**MISSOULA COUNTY**  
**REQUEST FOR QUALIFICATIONS ADDENDUM #1**

Marshall Mountain Park – Base Area Redevelopment Project (design and engineering)

ADDENDUM NUMBER: 1

Approximate location of observed items.

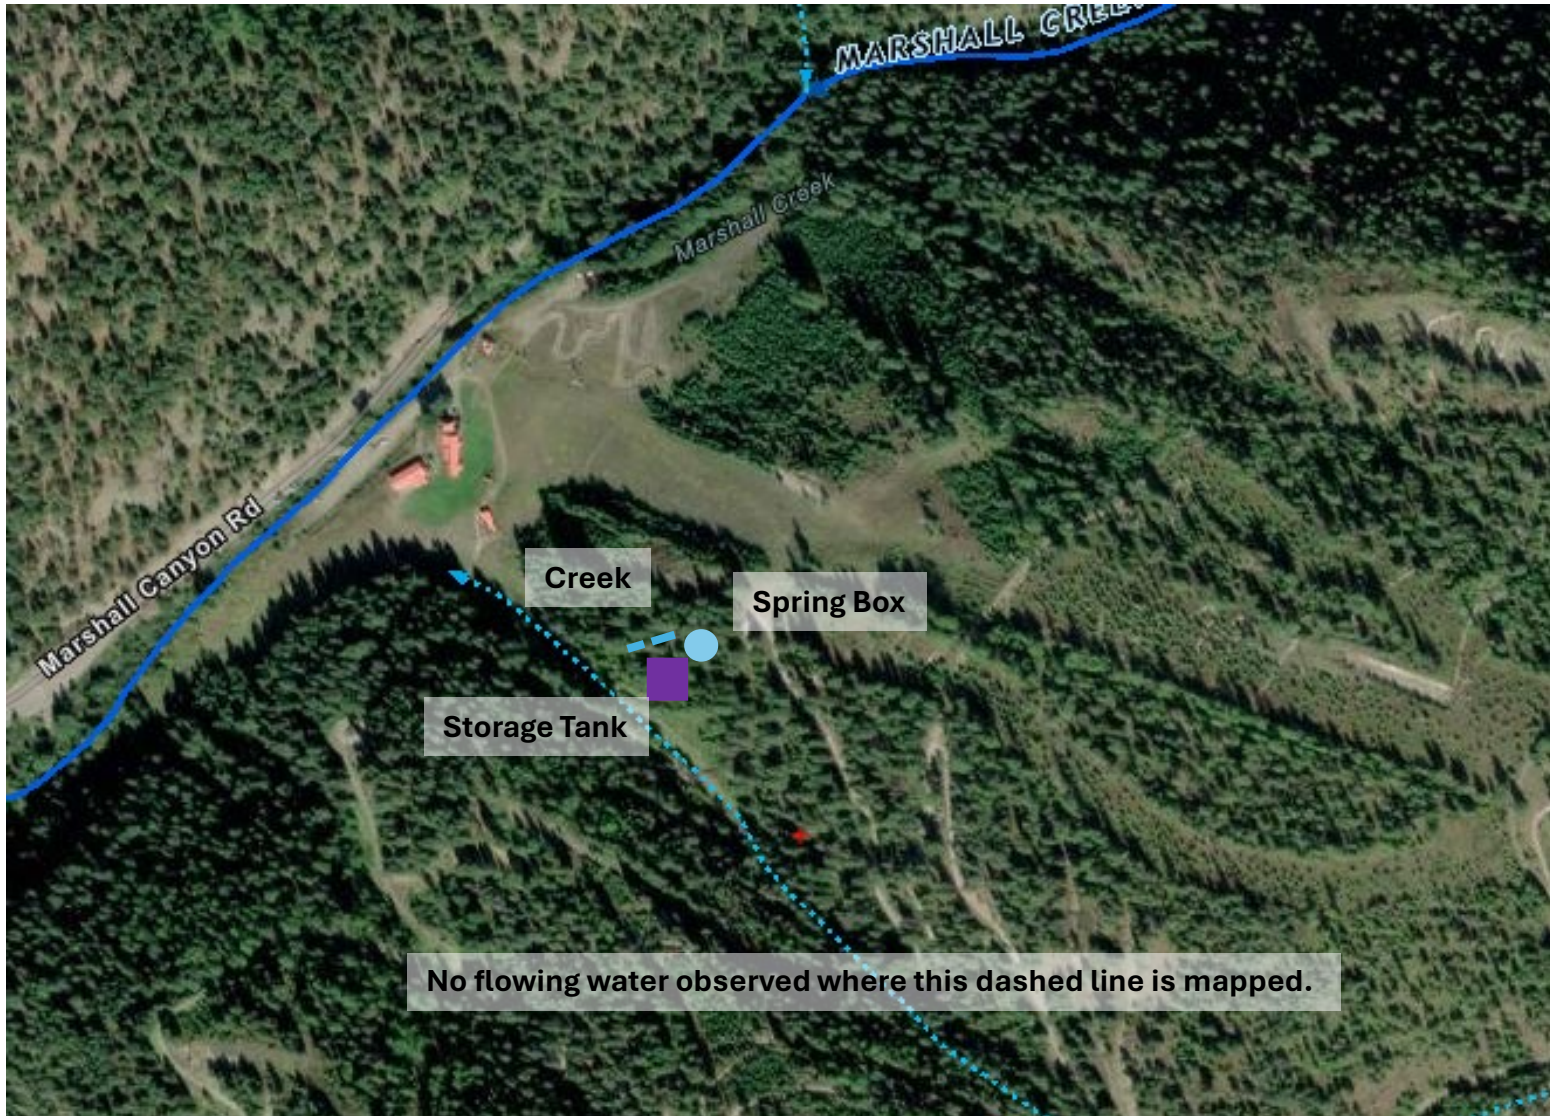
The spring box is built from concrete block with a metal shoebox style lid that acts as roof that was missing a gasket. Several live ants and debris in the water was observed. The spring box overflow is black plastic pipe that was not screened. Two PVC pipes was observed coming into the spring box from the hillside.

A buried pipe connected the spring box to a buried plastic storage tank. The storage tank lacked an overflow. I observed the storage tank overflowing from the lid. A gurgling sound was heard coming from an upside down U shape 1-inch PVC pipe adjacent to the storage tank. It was unclear the cause of the sound. The 1996 Sanitary Survey includes a sketch of the storage tank with down turned vent, which is what the upside down U shape PVC pipe may be. I suggest clearing debris from around the pipe to see if it is in fact a blocked vent for the storage tank. If this is the storage tank vent, it should be raised three pipe width's above the ground and screened.

West of the storage tank, a small flowing creek was observed. I recommend finding the source of this flowing water, as we were not able to find it. Is it another spring, surface run off, etc.?

I recommended that the spring box interior be cleaned, a gasket be installed on the lid, install 24 screen mesh on the spring box overflow pipe, can cut back the vegetation around the spring box. Then let the spring flush for at least one week, before conducting a microscopic particulate analysis (MPA) sample. A MPA sample will be useful to determine if the spring can be used as a groundwater source for a public water system. Ideally, two MPA samples would be taken, one in May-June and the other in August-September timeframe. The sample taken in May or June would be during a wet time of year and the sample taken in August or September would be from a dry time of year. There have been two previous MPA samples taken, June 1999 with a score of 0 points, and May 2000 with a score of 0 points.

I recommended that water not be served to the public at this time and wait until after securing DEQ Engineering review and approval before serving water to the public and being activated as a public water system.

## FULL DEMO AND REPLACEMENT - Main Level

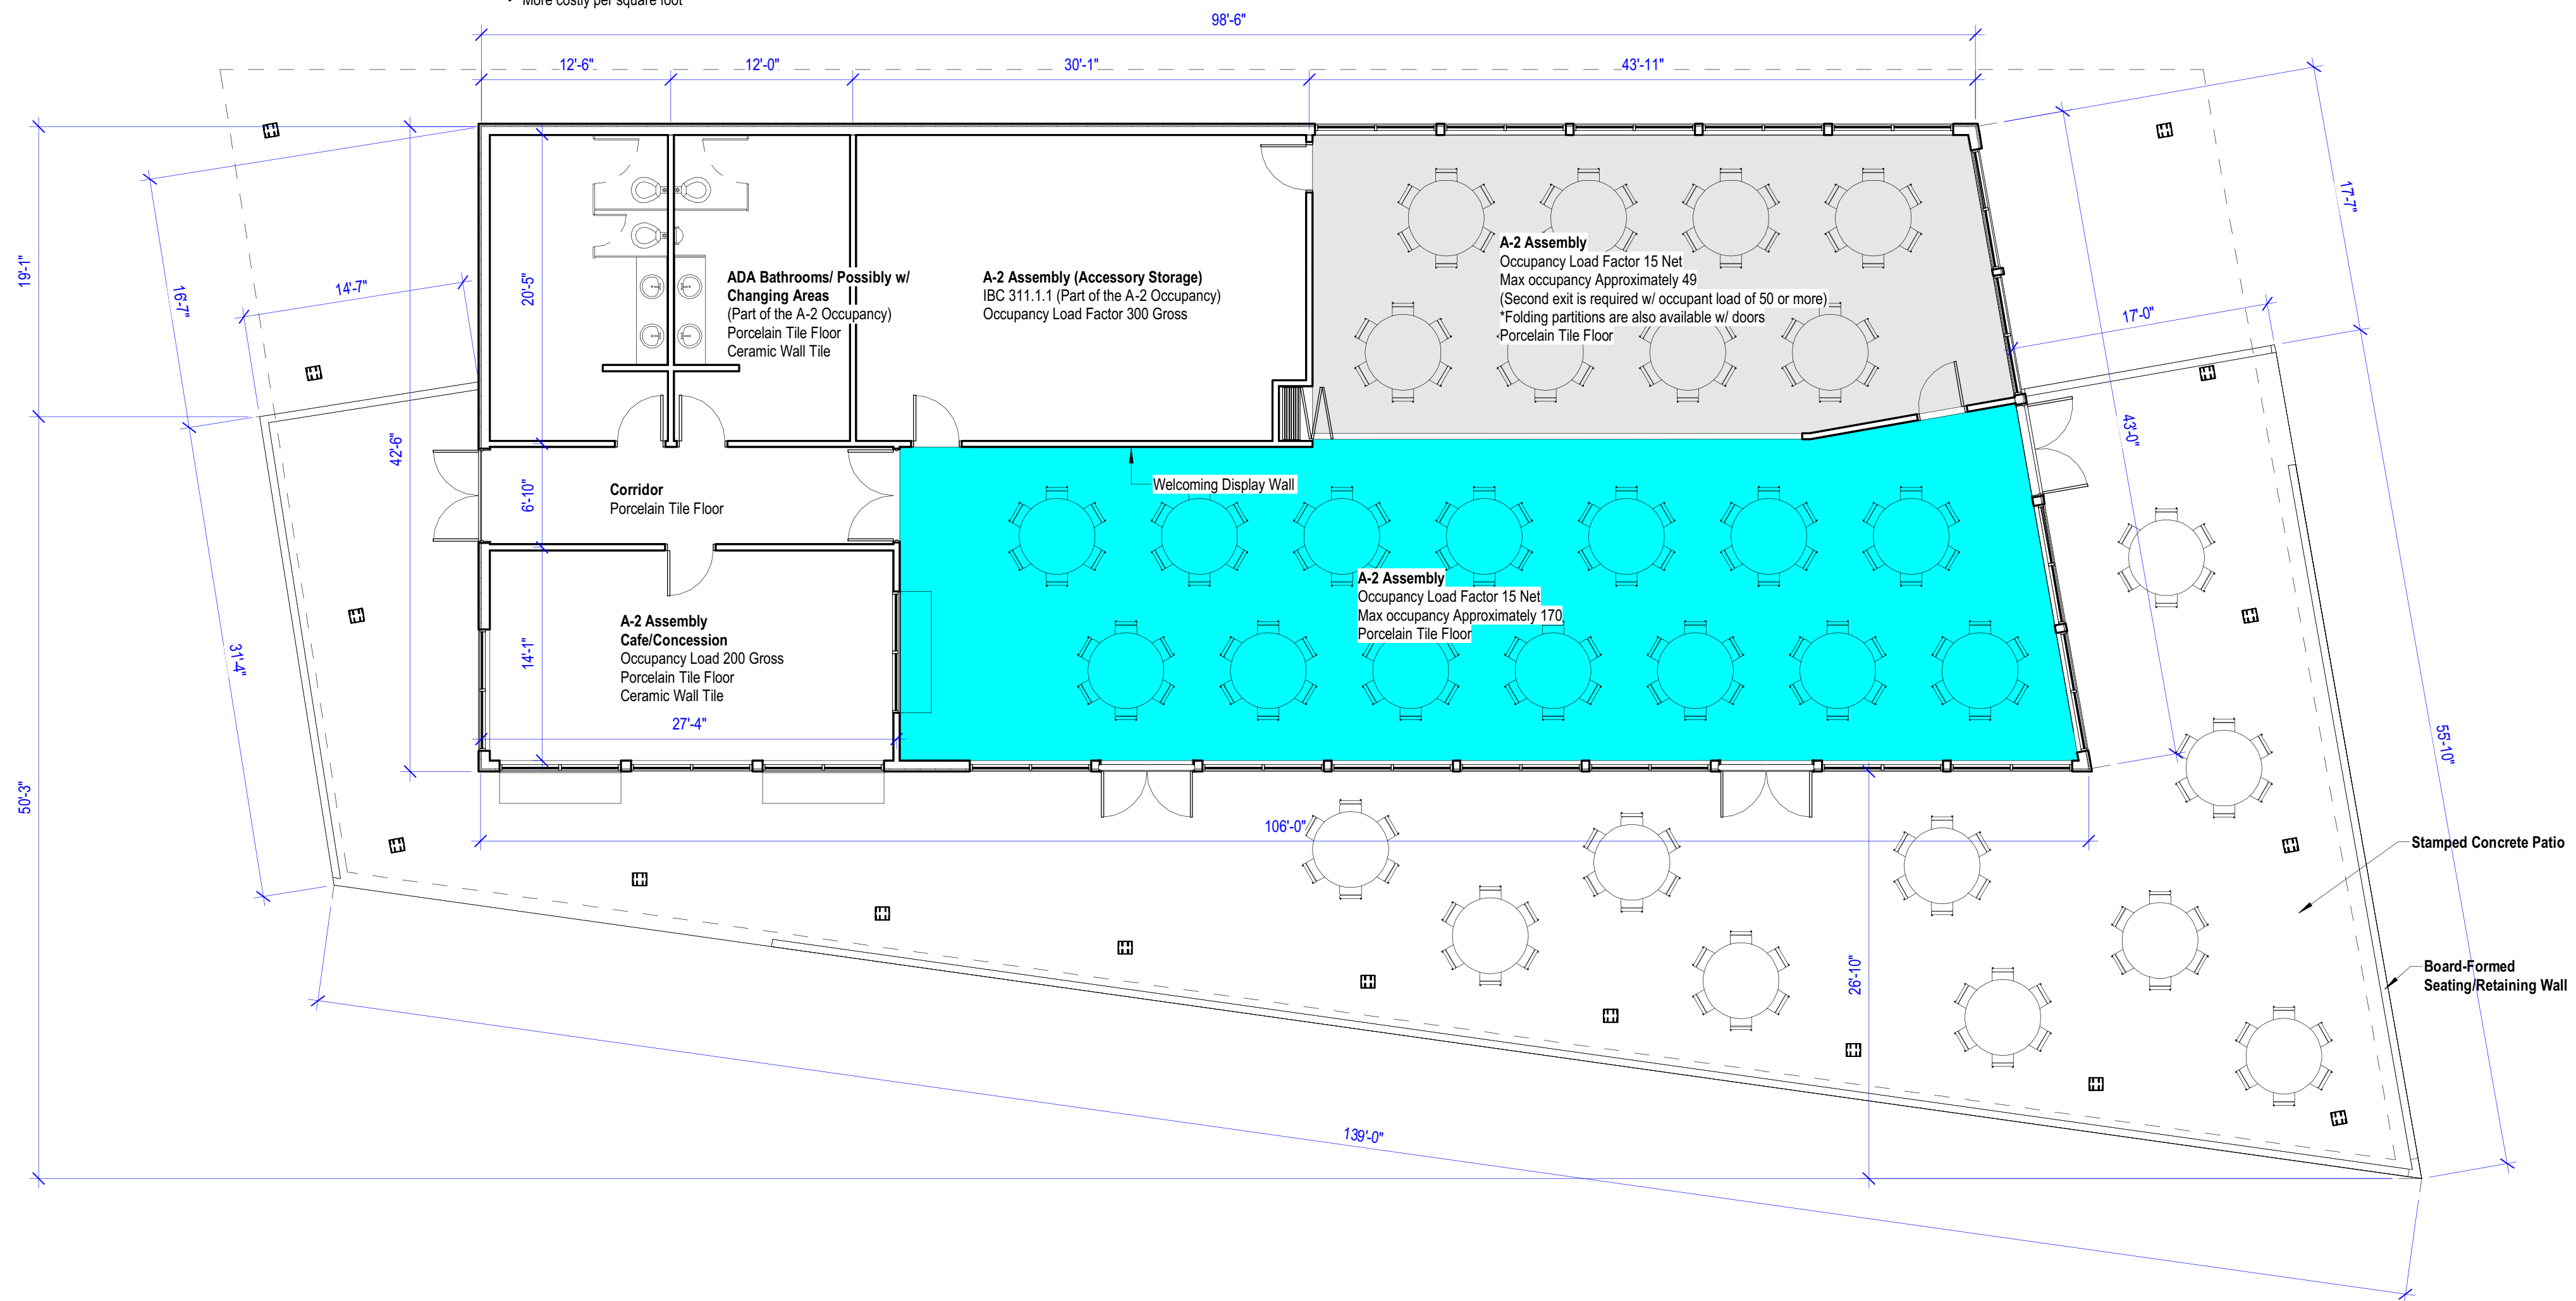
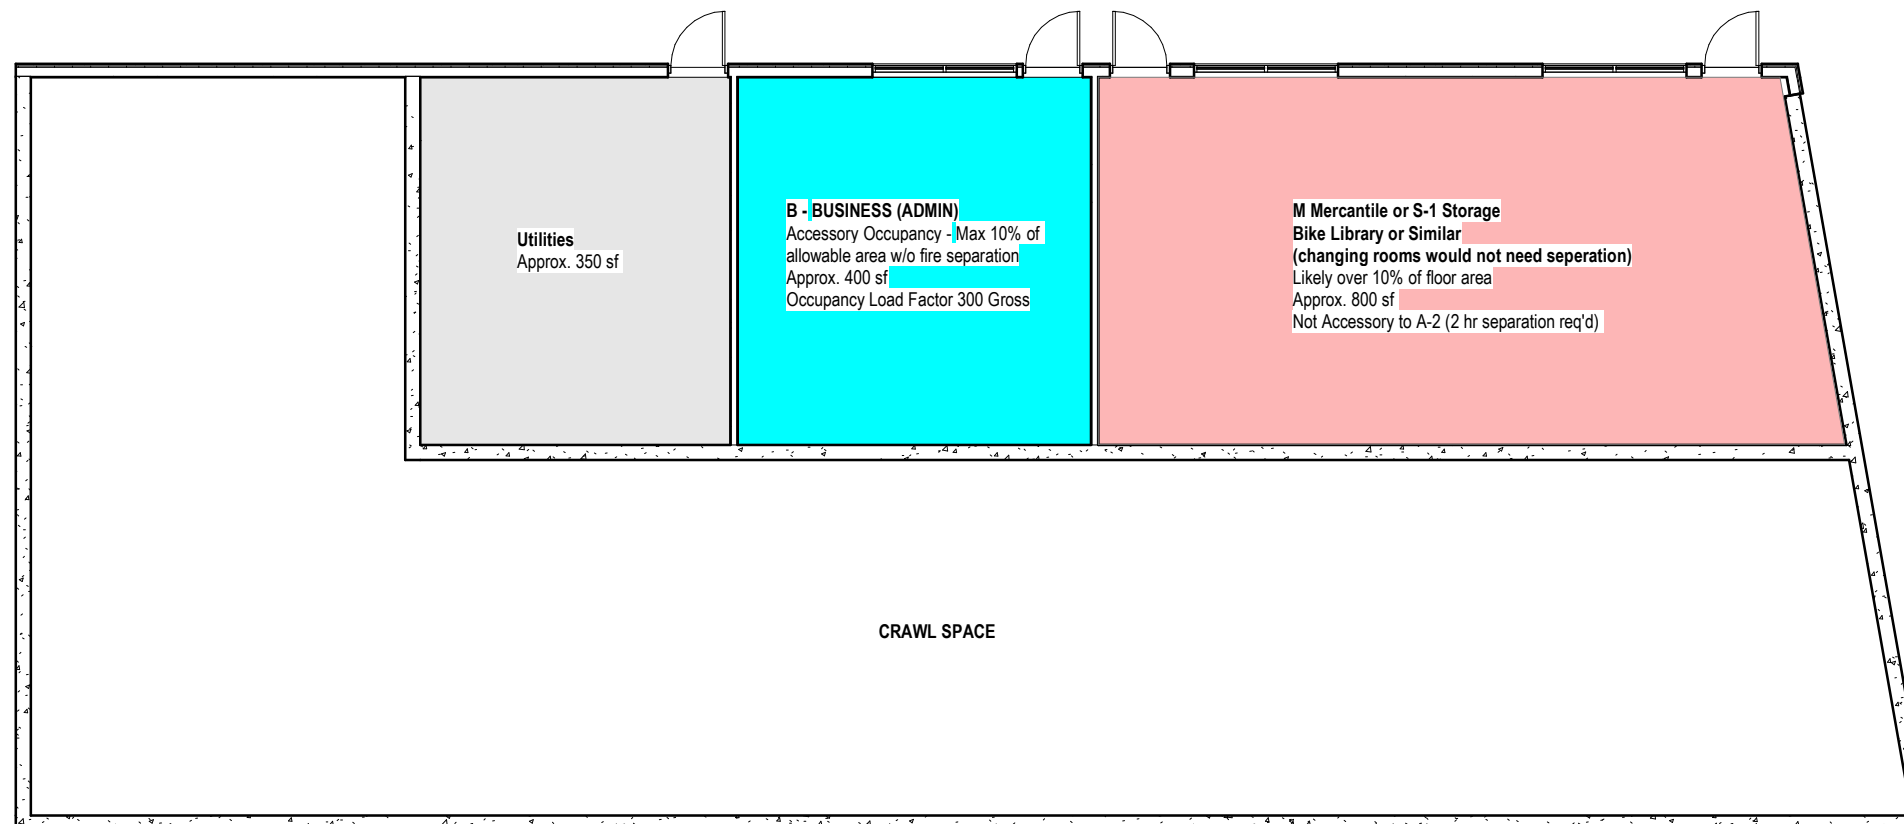
- a. Only the building your office is in will be hooked to a future water system correct?

**Answer #10. a:** The base building is the only *indoor* space that will be tied to the water system, but as stated within the RFQ narrative, “water system design will need to support the desired park operating capacity which includes an approximately 1-acre irrigated lawn space, supplemental landscaping, and public drinking water supply (base building and outdoor drinking fountains).” The building is slated for reconstruction/expansion in the future and demand will accordingly go up. See Exhibit B for *conceptual* floor plans to estimate demands.
